Subject: **WATER AND WASTEWATER CAPACITY AVAILABILITY LETTER**  
**The YMCA – DRC Case No. UDP-S24057**  
**840 N. Federal Highway, Fort Lauderdale, FL 33304**

City of Fort Lauderdale  
Public Works Department  
Water and Wastewater Capacity Analysis

**The YMCA – DRC Case No. UDP-S24057**  
**840 N. Federal Highway, Fort Lauderdale, FL 33304**

Figure 2 – City Sewer Atlas

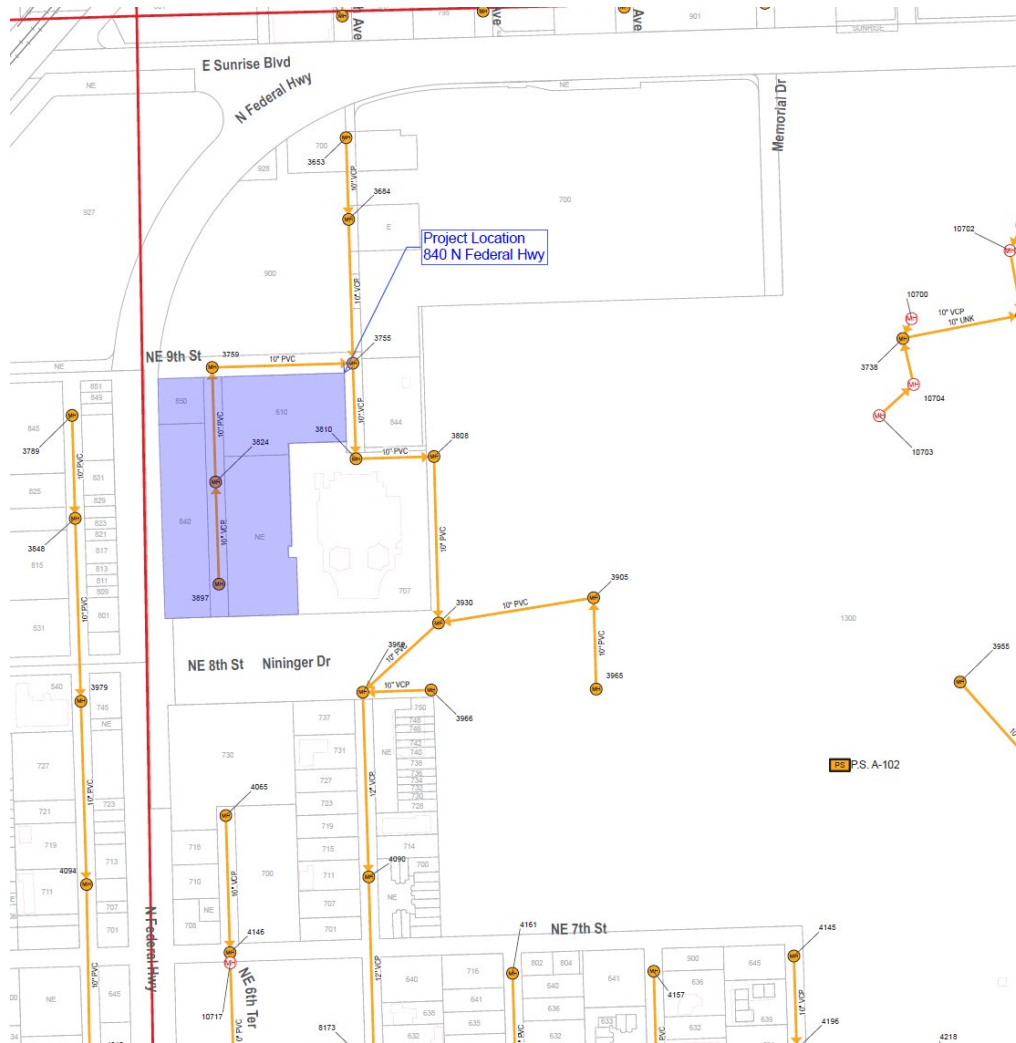
**Wastewater:** The site is currently served by a 10-inch gravity sewer main to the east of the project site along NE 6<sup>th</sup> Ter. See Figure 2.

**Figure 3 – Required Improvements (City Sewer)**

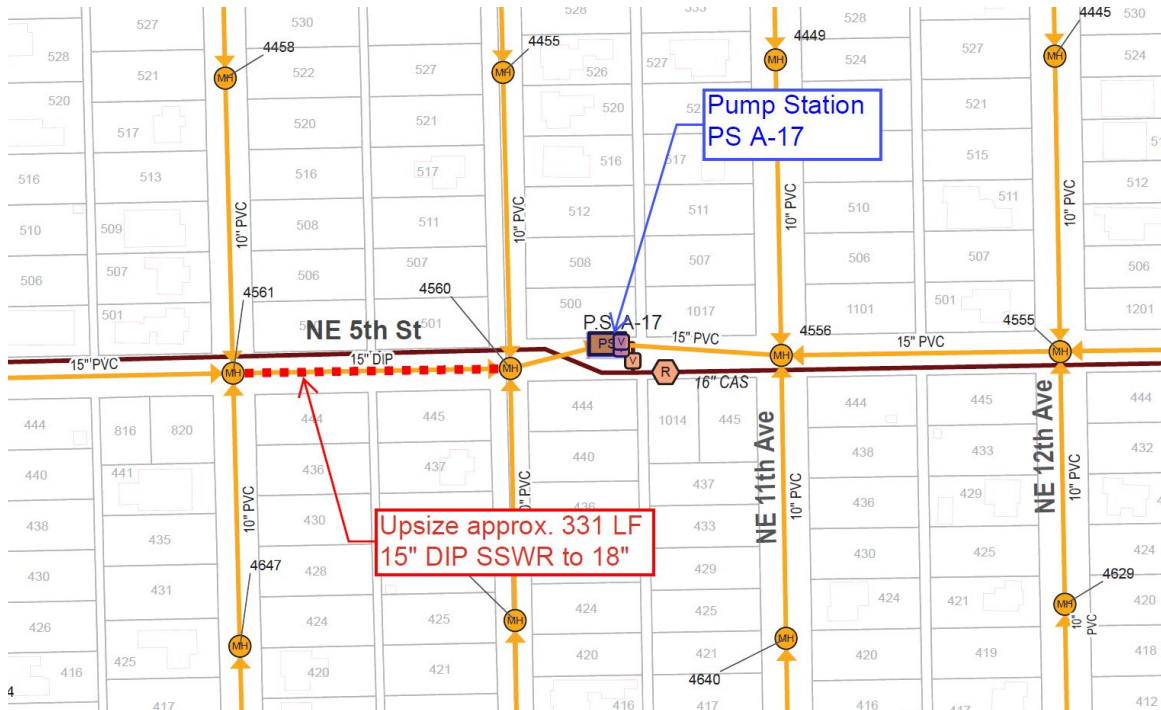
The proposed water infrastructure has the capacity to support the proposed development, however the sewer infrastructure requires improvements to meet the increased demand of the proposed project. See Figure 3 – Required Improvements. The master permit will not be issued for this site until the sanitary sewer system improvements are constructed, certified, and in service.

**Evaluation of impact on existing collection pipe:** According to the site plan, the applicant is proposing to utilize the 10-inch PVC gravity sewer main to the north of the project site along NE 9<sup>th</sup> St via connection to the existing manhole SSMH-3759. Accounting for existing flows and based on the tools and information available to the City staff, it has been calculated that approximately 331 LF of 15-inch piping (pipe ID No. SSGM-635) will flow higher than the City's governance plan threshold of 70% during peak flows, resulting in the pipe run being surcharged. This length of pipe must be upsized to 18-inch pipe which is estimated to lower the pipe's peak flow to 52.23%.

Figure 4

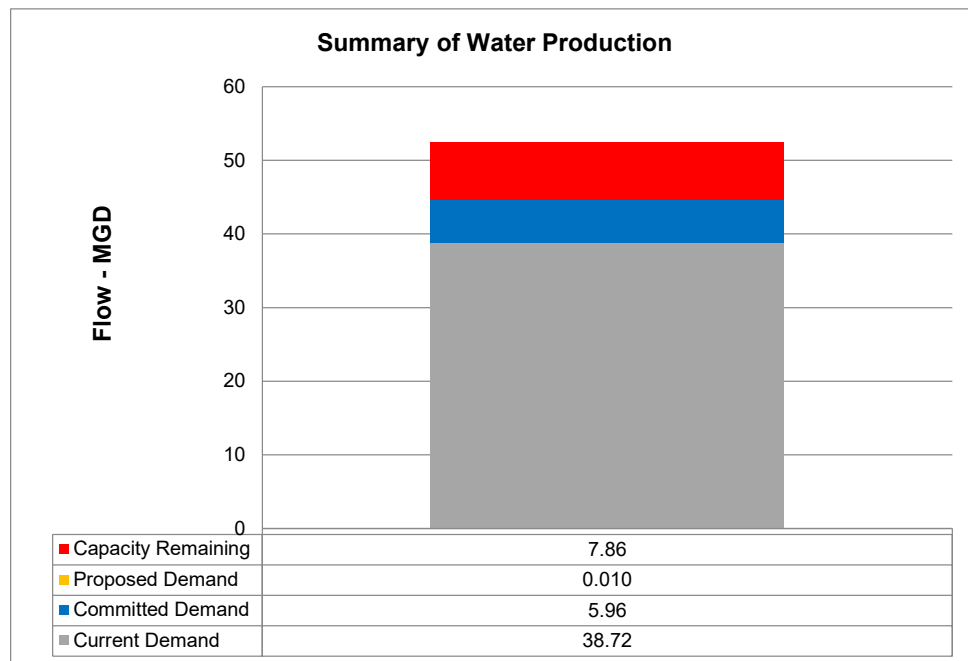
The current twelve-month rolling average production at the two plants is 38.72 MGD. The previously committed demand from development projects in the permitting or the construction stage is 5.96 MGD. Combining these figures with the demand from the proposed project of 0.0101 MGD, the required production would be 44.69 MGD. This is less than the allowable withdrawal limit of 52.55 MGD. Therefore, the water plants have sufficient capacity to serve this project. See Figure 4 below.

Figure 5

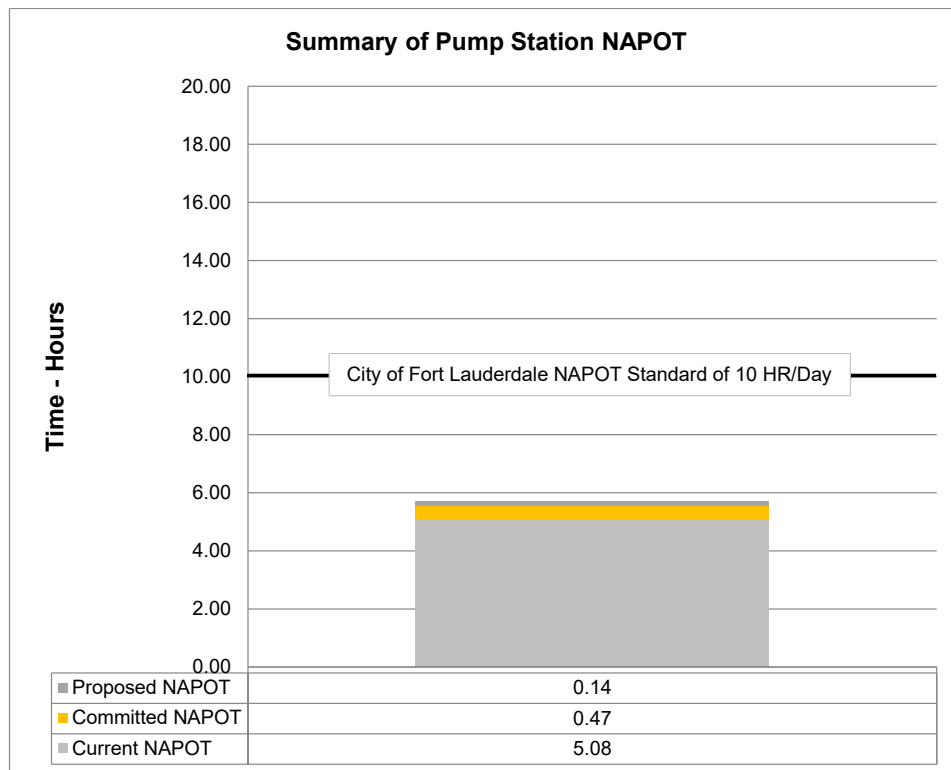
**Evaluation of impact on pumping station:** PS A-17 has a duty point of 843 gallons per minute (GPM) and has a Nominal Average Pumping Operating Time (NAPOT) of approximately 5.08 hours per day. Based on projected sewage flows, the pumping run times would increase approximately 8 minutes per day. Additionally, there are other committed flows from proposed developments within the PS A-17 basin resulting in 28.29 minutes of additional runtime. PS A-17 will have a NAPOT of 5.69 hours once the proposed developments are complete, less than the recommended average of 10 hours per day. See Figure 5 below.

Figure 6

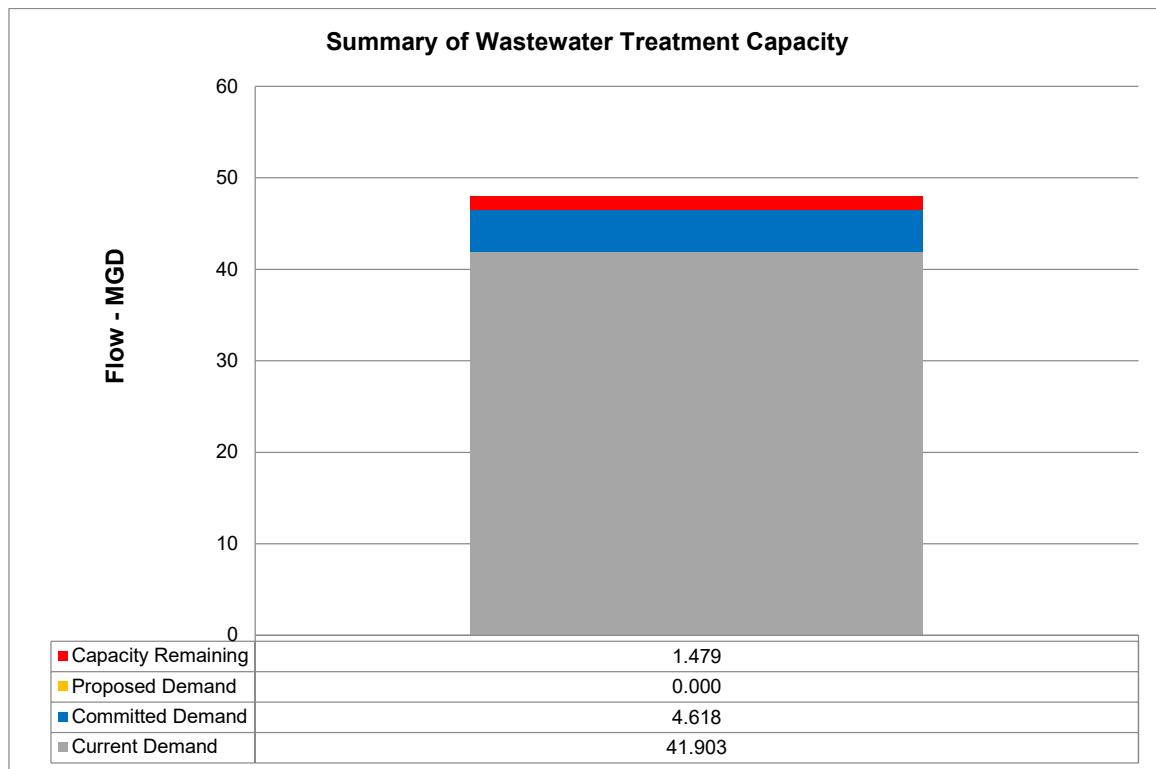
**Evaluation of impact of Permitted Wastewater Plant Capacity:** The City of Fort Lauderdale owns and operates the George T. Lohmeyer Regional Wastewater Treatment Plant (GTL), which provides wastewater treatment for the City of Fort Lauderdale. The Florida Department of Environmental Protection's (FDEP) permitted capacity for GTL is 56.6 MGD-TMADF (Million Gallons per Day – Three Month Average Daily Flow). The three-month average daily flow (TMADF) to the plant is 39.45 MGD. Combining the committed flows for previously approved projects of 4.65 MGD plus the 0.0069 MGD net contribution from the project results in a total projected flow of 44.11 MGD. This is less than the permitted treatment plant capacity of 56.6 MGD. Therefore, the treatment plant has sufficient capacity to serve this project. See Figure 6 below.
